ADDENDUM 2

CSP 22-68

Memorial Middle School Heating & Air Condition (HVAC) Improvements Funded through the Elementary & Secondary Emergency Relief (ESSER) Funds

April 8, 2022

MECHANICAL LEGEND
SHEET NUMBER: M0.01
DBR Project Number: 218007.002
HA JA JB ---

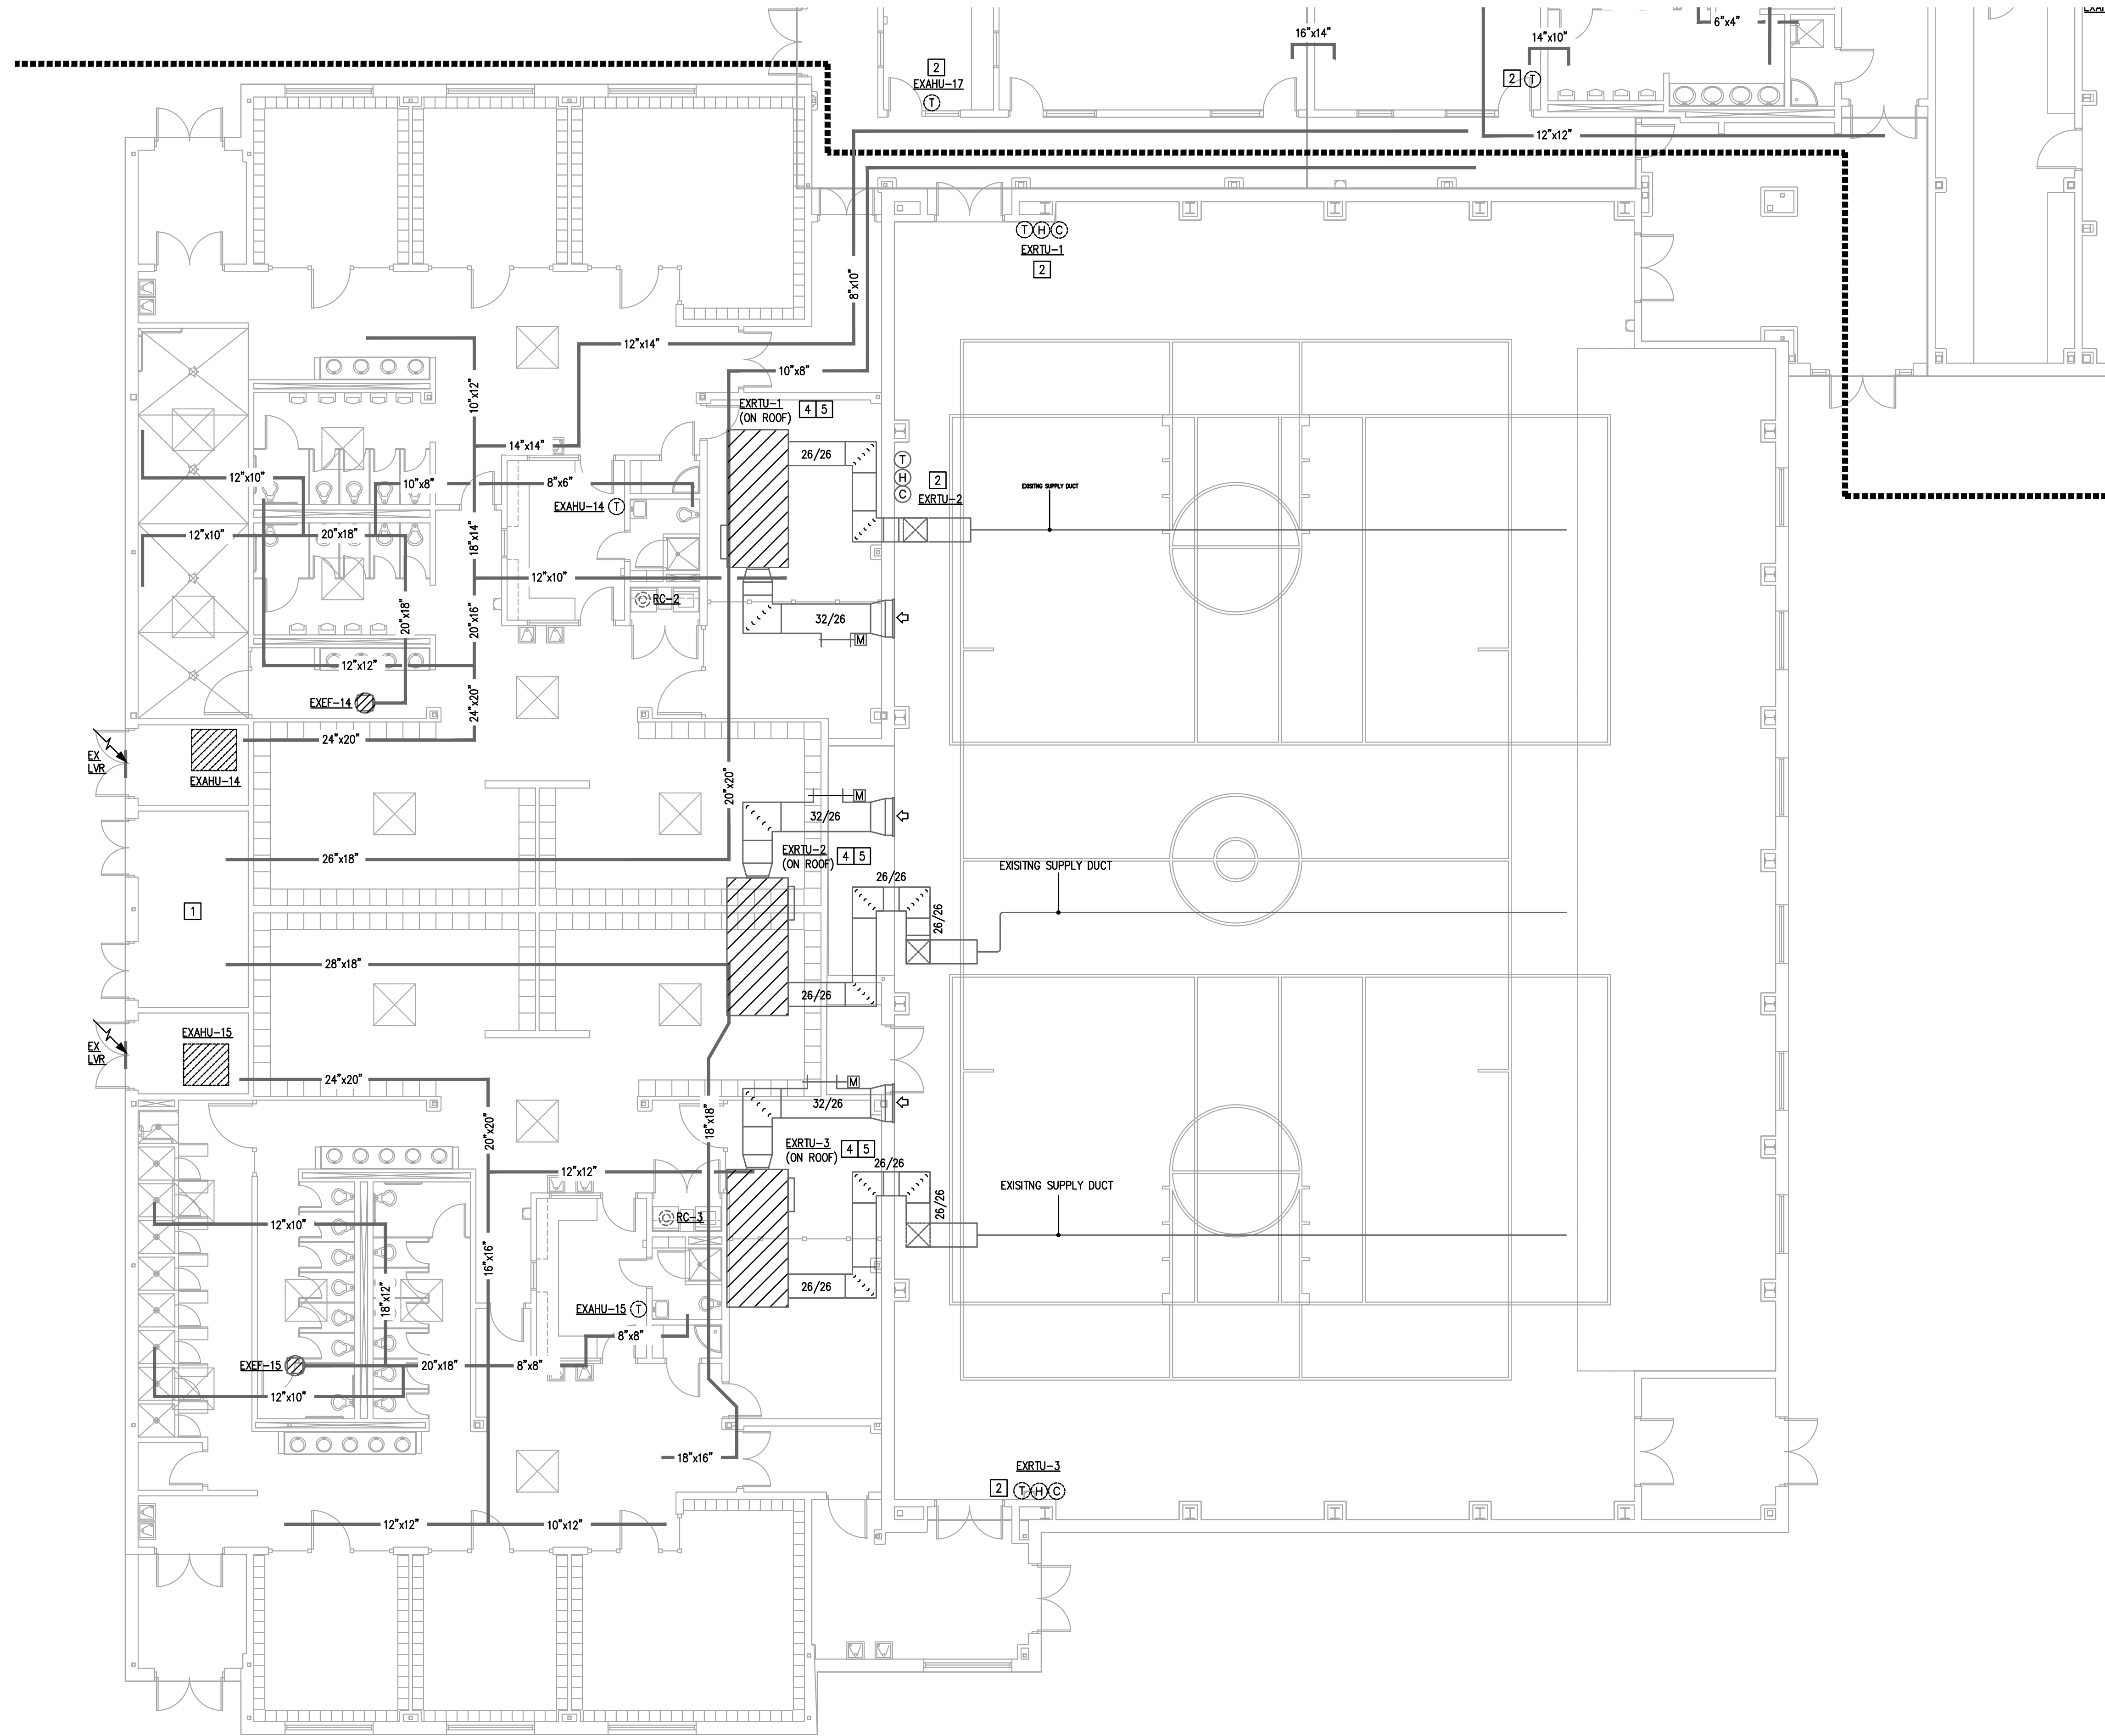
Item 02 SHEET M0.01 – MECHANICAL LEGEND

A. Added general note 23.

23. WHERE NEW SPRINKLER HEADS MUST BE ADDED UNDER FIXED OBSTRUCTIONS (DUCTWORK) OVER 4 FEET WIDE PER NFPA 13, 8.6.5.3.3, PROVIDE PIPING, FITTINGS, JOINING METHODS, AND SPRINKLER HEADS TO MATCH EXISTING TYPE. FIELD VERIFY.

MD2.12F

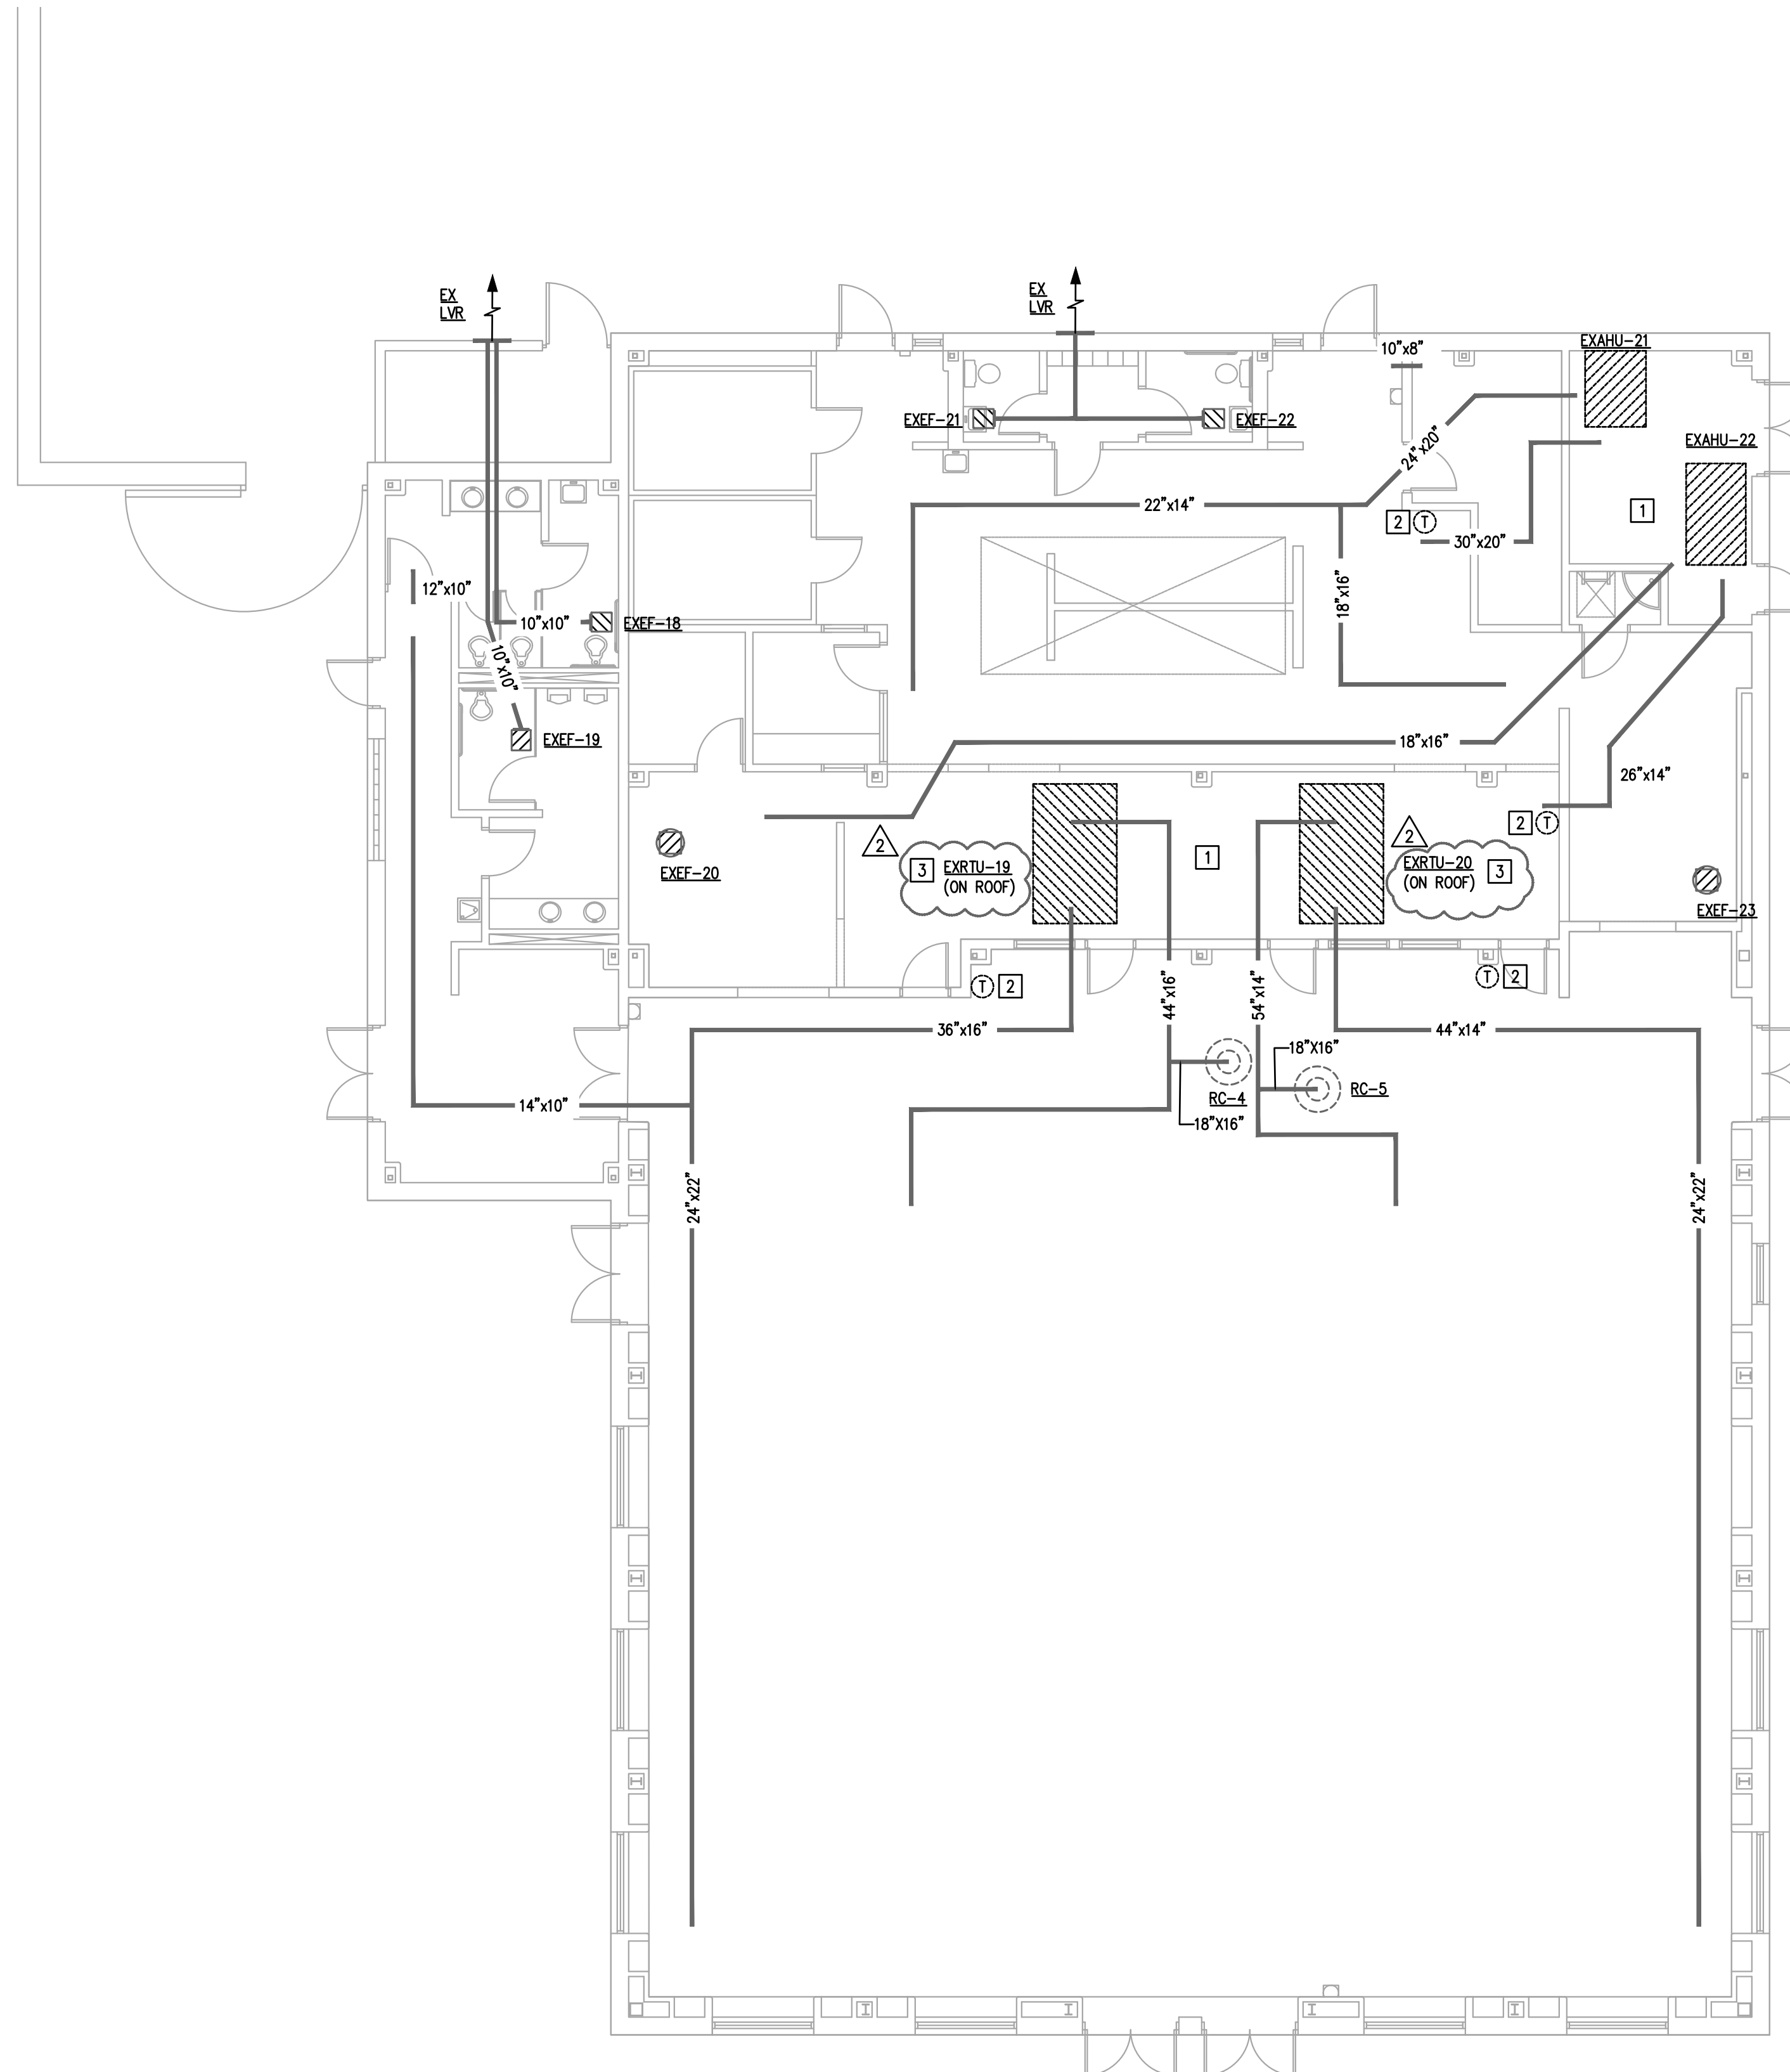
Item 03 SHEET MD2.12F – LEVEL 1 MECHANICAL DEMO PLAN – F.

A. Revised keyed notes 2 and 3.

DATE:	4/7/2022
DRAWN BY:	DBR
CHECKED BY:	DBR
PROJECT NUMBER:	218007.002
SHEET TITLE:	LEVEL 1 MECHANICAL DEMO PLAN - G
SHEET NUMBER:	MD2.13G

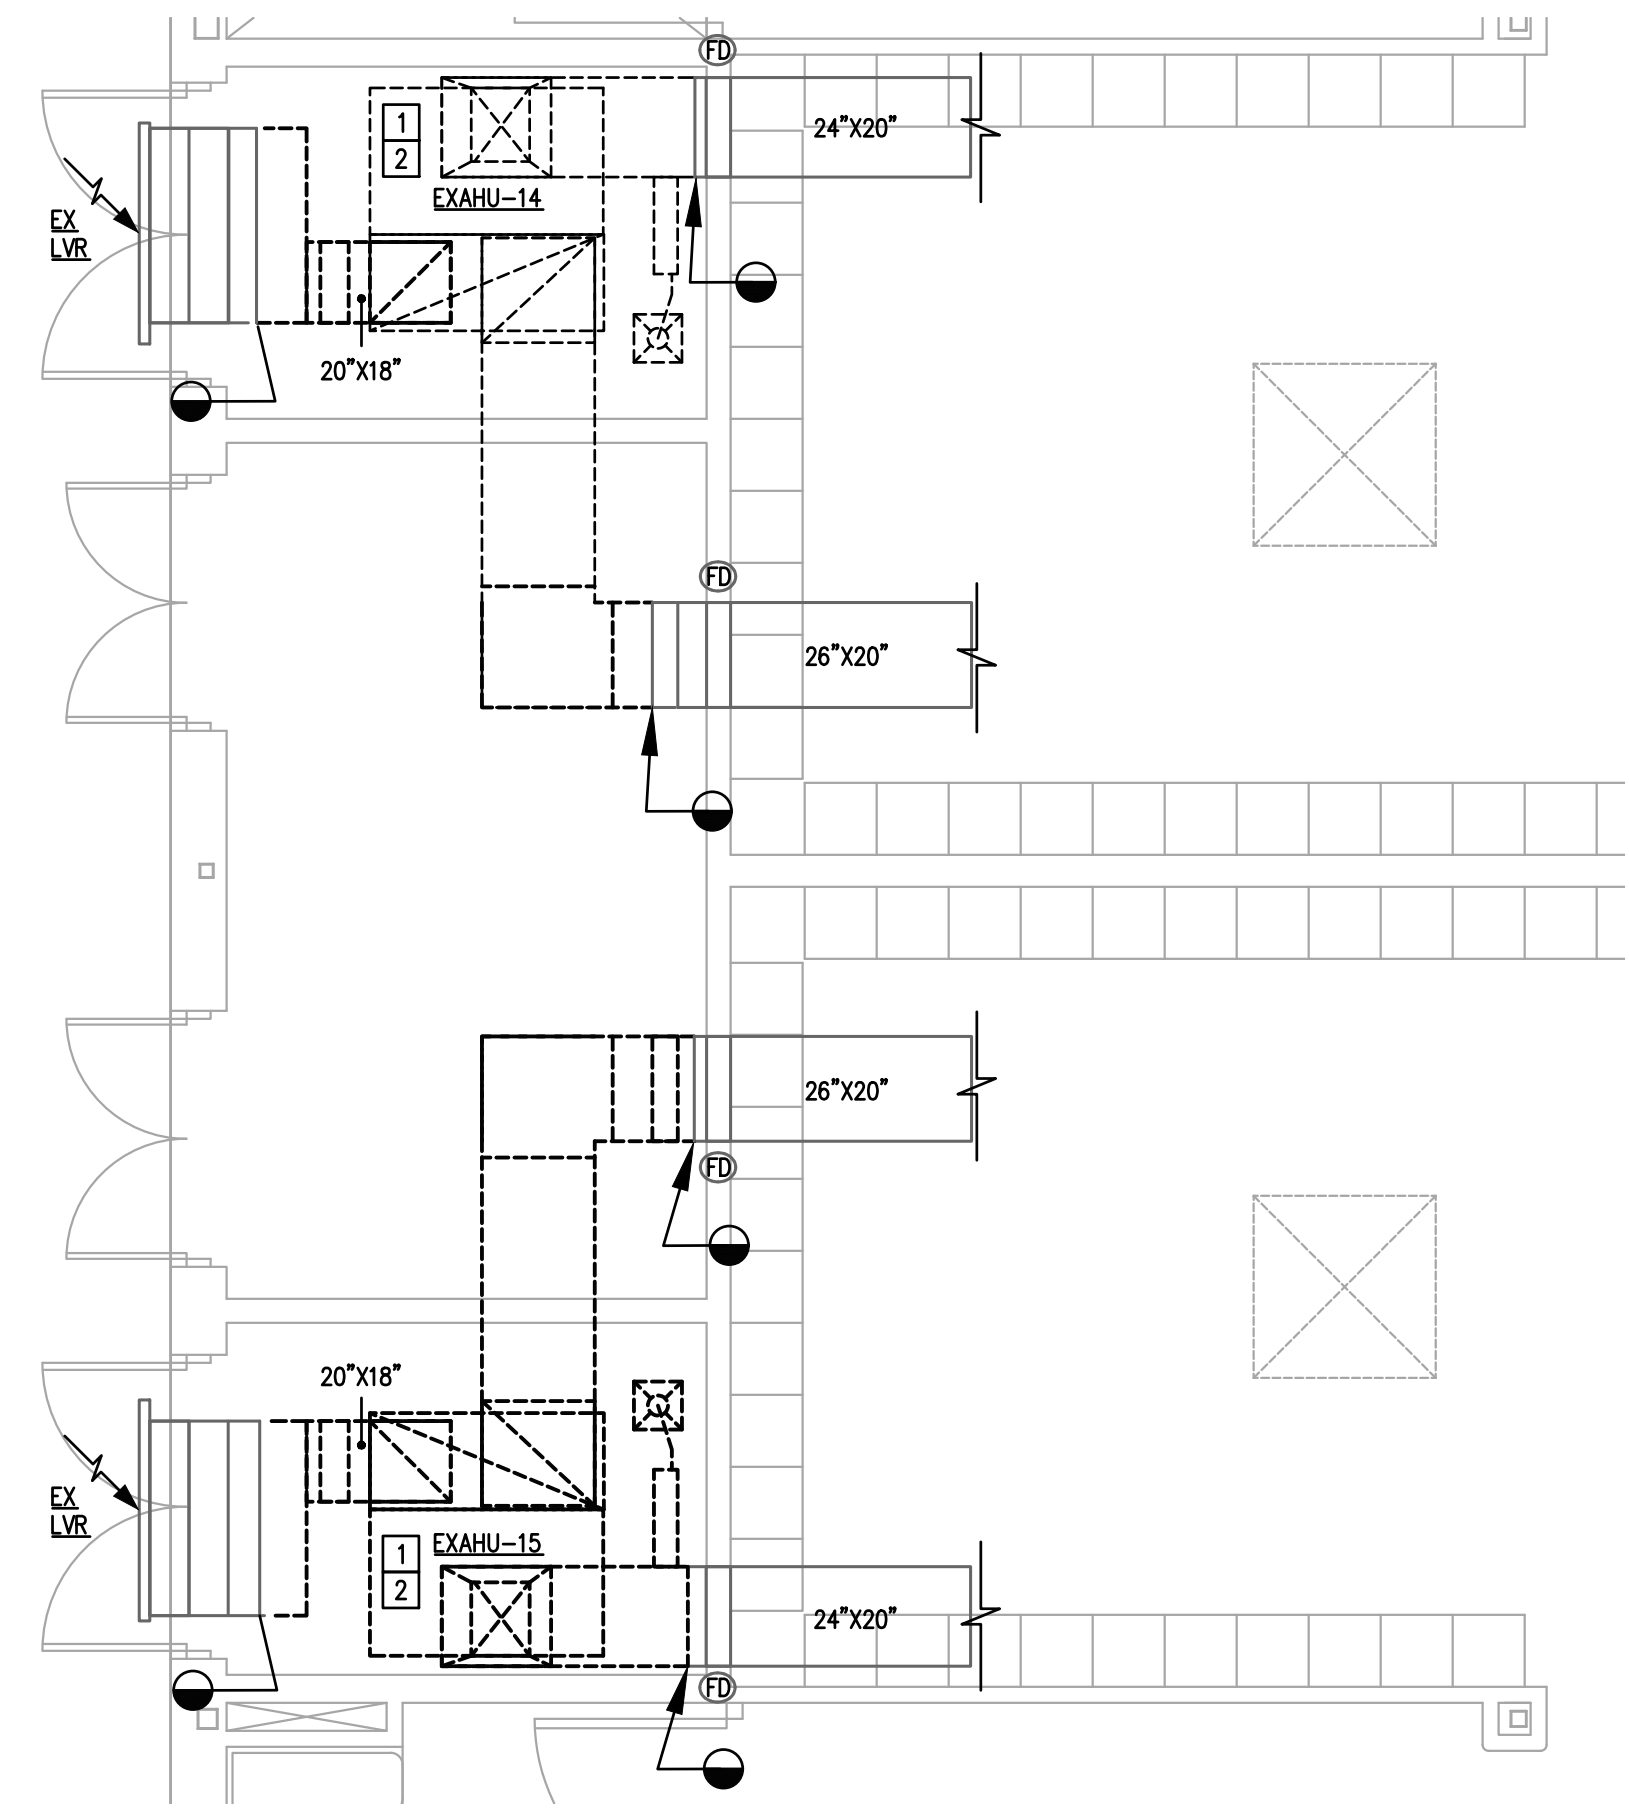
Item 04 SHEET MD2.13G – LEVEL 1 MECHANICAL DEMO PLAN – G.

A. Replaced keyed note 4 with keyed note 3 for EXRTU-19 and EXRTU-20.
